**BEFORE THE PUBLIC UTILITIES COMMISSION OF THE STATE OF CALIFORNIA**

In the Matter of the Application of the San Diego Metropolitan Transit Development Board and the City of San Diego for an order authorizing construction of an at-grade crossing on two existing light rail vehicle tracks at Fenton Parkway in the City of San Diego, California.

Application 02-04-050  
(Filed April 30, 2002;  
Supplement filed  
January 26, 2004)

### CROSSING WARNING DEVICES AND CROSSING SECTION

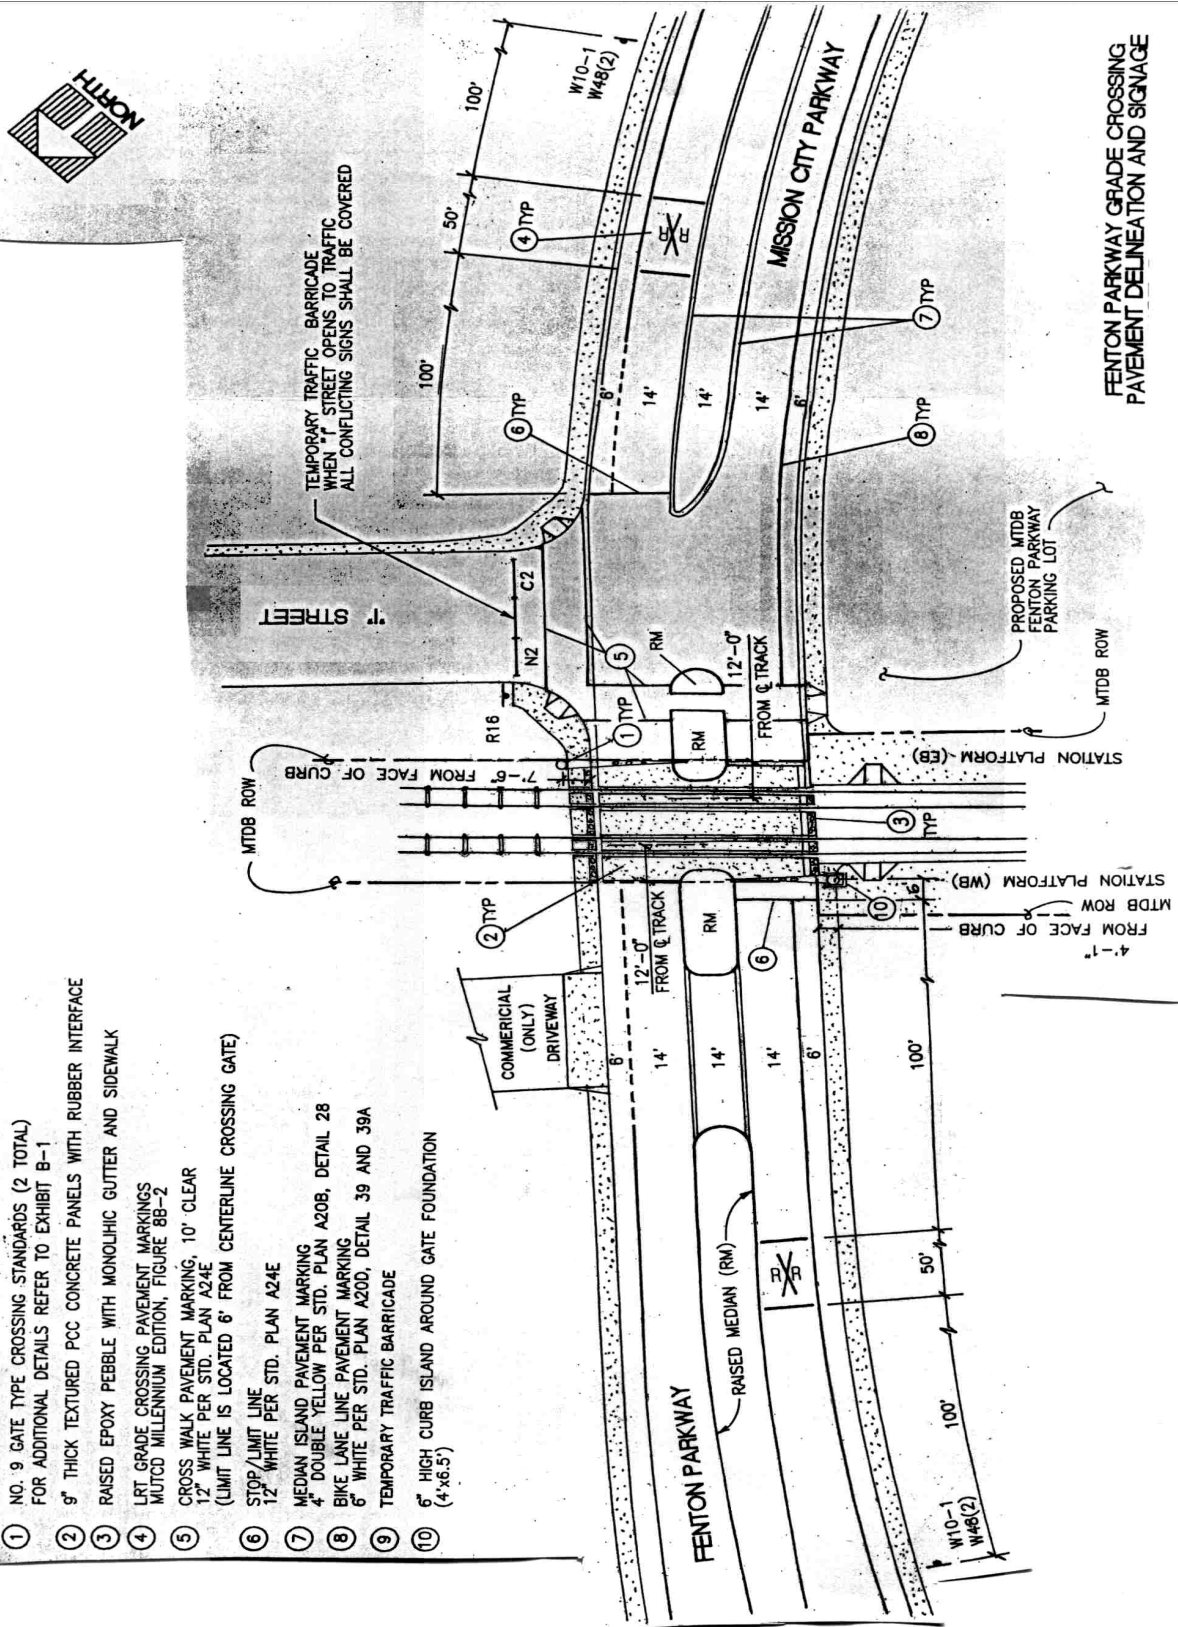
At the proposed crossing, MTDB and City request a deviation from Section 7.8 of GO 75-C, which requires the constant ringing of bells at crossings when passing trains activate the warning devices. To reduce noise at the proposed crossing, MTDB and City request to modify the warning devices so that bells sound only during the initial warning and descent stages until the automatic gates are within 10 degrees of the horizontal position.

As there were no identified environmental impacts related to noise, we find that there is no need to grant MTDB's request for a deviation from Section 7.8 of GO 75-C to allow MTDB to silence the bells on the automatic warning devices until the automatic gates are within 10 degrees of the horizontal position. Due to the adjacent Fenton Trolley Station, residential community and surrounding commercial establishments, we believe that the continuous sounding of the bells on the automatic warning devices is essential for public safety by providing an audible warning to pedestrians in the area.

Due to the adjacent Fenton Trolley Station, residential community and surrounding commercial establishments, the continuous sounding of the bells on the automatic warning devices is essential for public safety by providing an audible warning to pedestrians.

6. MTDB's request for a deviation from Section 7.8 of GO 75-C is denied. MTDB shall ensure that the bells sound continuously during each activation of the Standard No. 9 warning devices and that the automatic gates at the crossing shall remain in a horizontal position to deny vehicular access across the LRV

## APPENDIX B PLANS

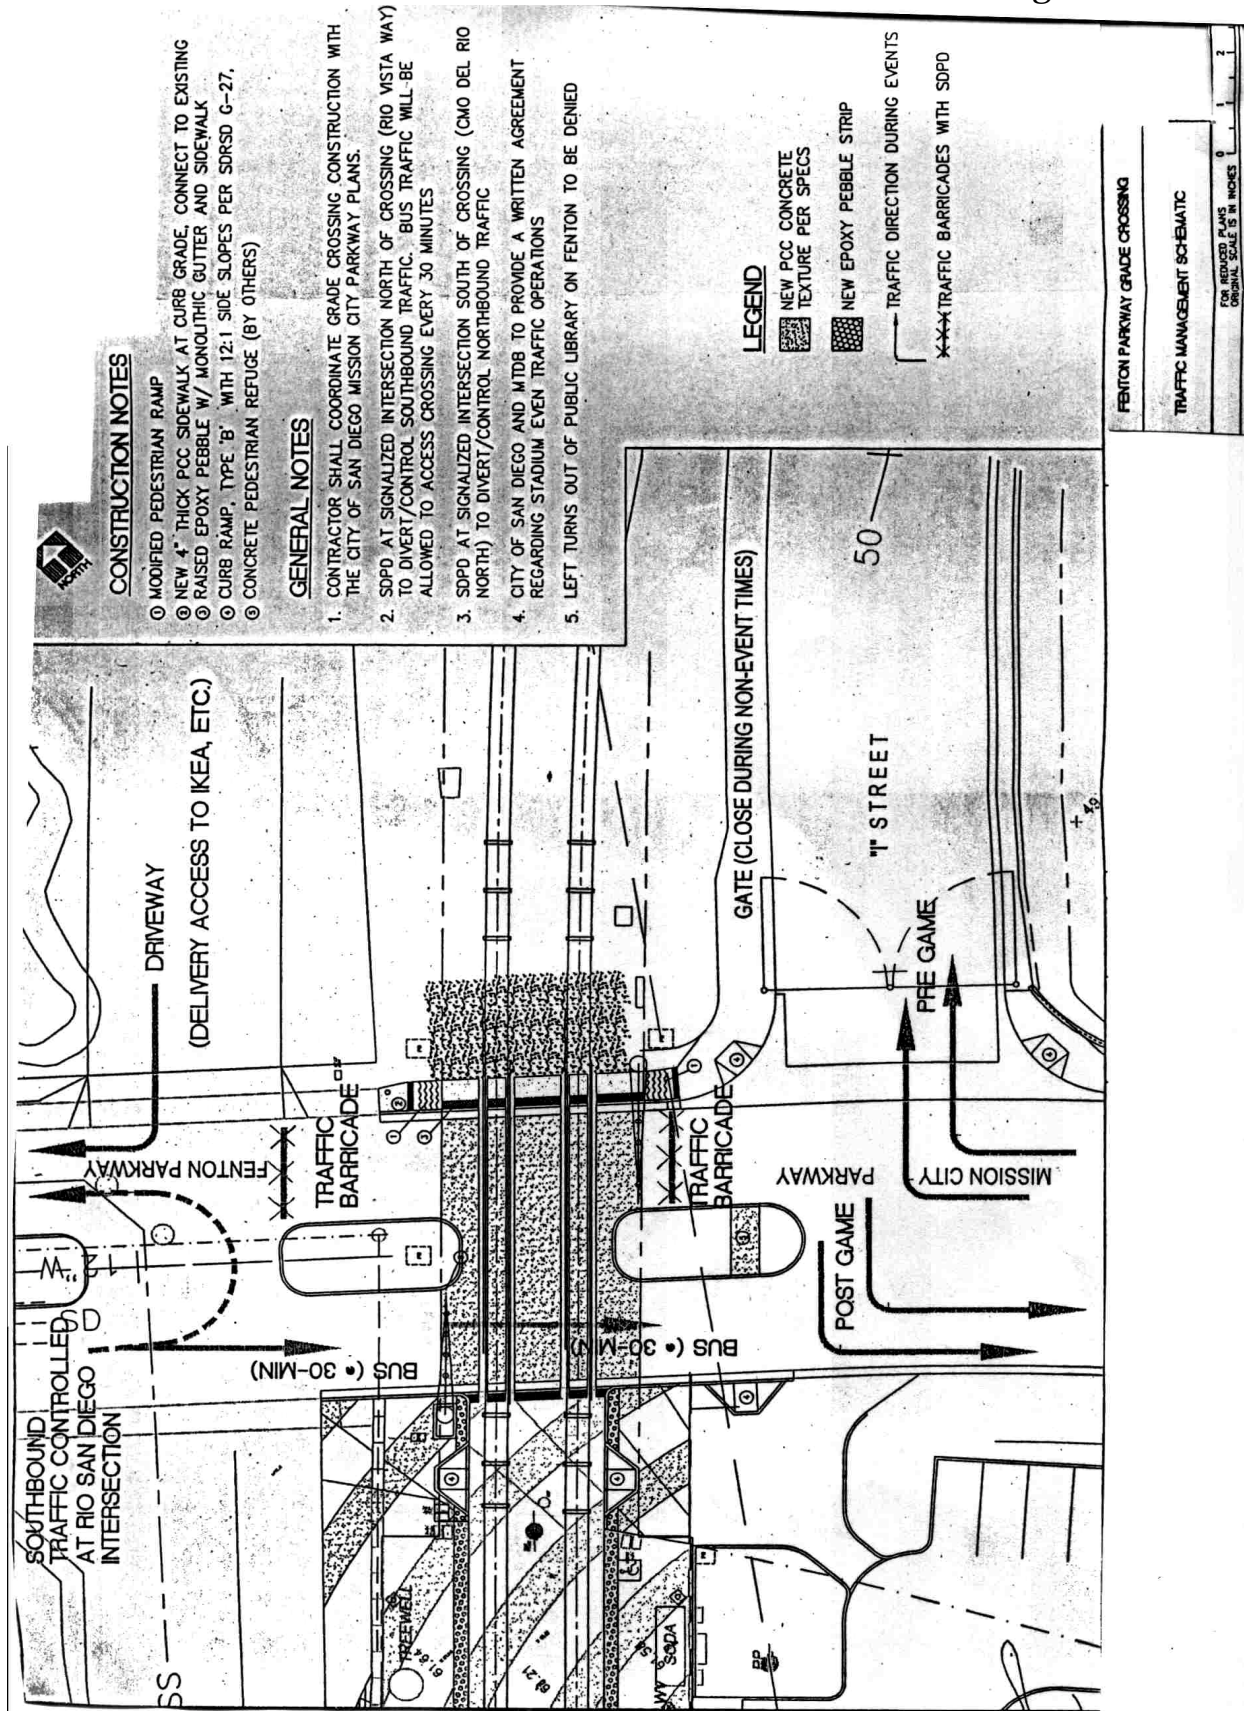
At the proposed crossing, MTDB requests an exemption from GO 72-B to allow the use of a rubber-rail interface within the flangeway of the proposed concrete slab crossing surface, as described in GO 72-B, Standard No. 8. By reducing the flangeway gap, the interface, which will reduce the flangeway width from the maximum 2 ½-inch width to an approximate 1-inch width, is necessary to enhance safety for bicyclists and pedestrians, including persons in

RCES reviewed MTDB's request for an exemption from GO 72-B to allow the use of a rubber-rail interface within the flangeway of the proposed concrete slab crossing surface, as described in GO 72-B, Standard No. 8. RCES concurs with MTDB's determination that the interface will provide an improved automotive ride and will reduce maintenance costs. RCES determined that the interface, which will reduce the flangeway width from the maximum 2 ½-inch width to an approximate 1-inch width, will enhance safety for bicyclists and pedestrians, including persons in wheelchairs, by reducing the flangeway gap.

13. MTDB requested an exemption from GO 72-B to allow the use of a rubber-rail interface within the flangeway of the proposed concrete slab crossing surface, as described in GO 72-B, Standard No. 8. By reducing the flangeway gap, the interface, which will reduce the flangeway width from the maximum 2 ½-inch width to an approximate 1-inch width, will enhance safety for bicyclists and pedestrians, including persons in wheelchairs; provide an improved automotive ride; and reduce crossing surface maintenance costs.

7. MTDB is authorized an exemption from GO 72-B to allow the use of a rubber-rail interface within the flangeway of the proposed concrete slab crossing surface, as described in GO 72-B, Standard No. 8. In all other respects, GO 72-B shall remain in full force and effect.
